Subject: MAMG-100227-010C0L Changes

PCN #: PCN-01307

Old Marking

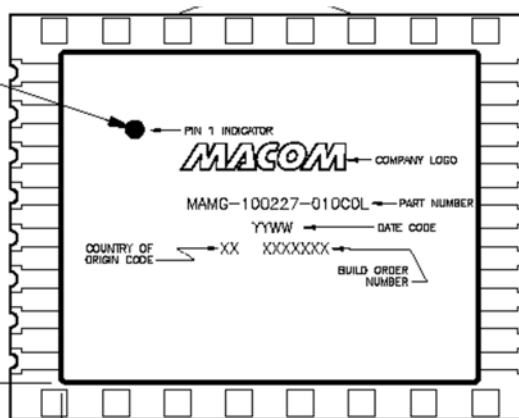
The part marking will also be changed as follows:

New Marking
